UNITED STATES PATENT AND TRADEMARK OFFICE

APPLICATION NO.	FILING DATE	FIRST NAMED INVENTOR	ATTORNEY DOCKET NO.	CONFIRMATION NO.
10/789,372	02/26/2004	Gottfried Mueller	HOE-803	5135
20028	7590	03/29/2007	EXAMINER	
Lipsitz & McAllister, LLC 755 MAIN STREET MONROE, CT 06468			DOWE, KATHERINE MARIE	
			ART UNIT	PAPER NUMBER
			3734	
SHORTENED STATUTORY PERIOD OF RESPONSE	MAIL DATE	DELIVERY MODE		
3 MONTHS	03/29/2007	PAPER

DETAILED ACTION

FIG. 2B.

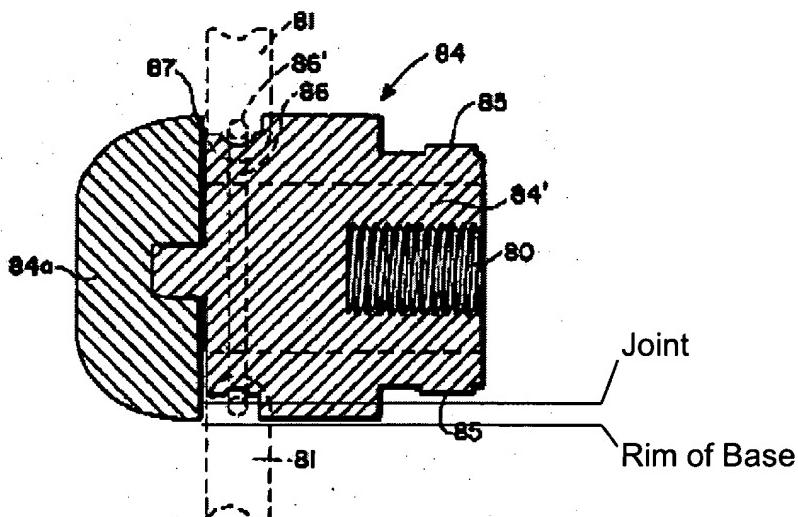
Regarding claim 15, King et al. disclose the joints are set back from a circumferential rim of the base part (see Fig 2B below).

FIG. 2B.

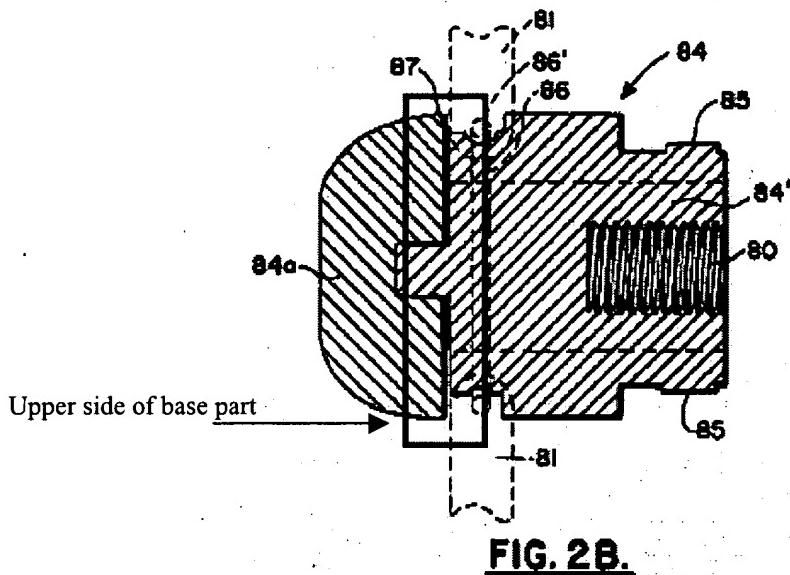
11. Applicant's arguments filed 2/5/2007 with respect to cancelled claim 16, of which subject matter is now included in claim 1, have been fully considered but they are not persuasive. Applicant argues that King does not disclose the joints are seated on an upper side of the base part, where the upper side of the base part faces the tissue when bearing areas bear on the tissue. As stated in the rejection, the upper side of the base part in King's invention is defined as the right portion of element 84a as shown below:

Thus, as can be seen in the picture, the joints formed by hinge holes 86' such that the wings (81) may swivel between a flapped-in position and flapped out position. As shown in Fig 2A, the wings are approaching a flapped-in position, but they are capable of swiveling further in toward mandrel (3) such that they do not protrude laterally over the base part in the flapped-in position.
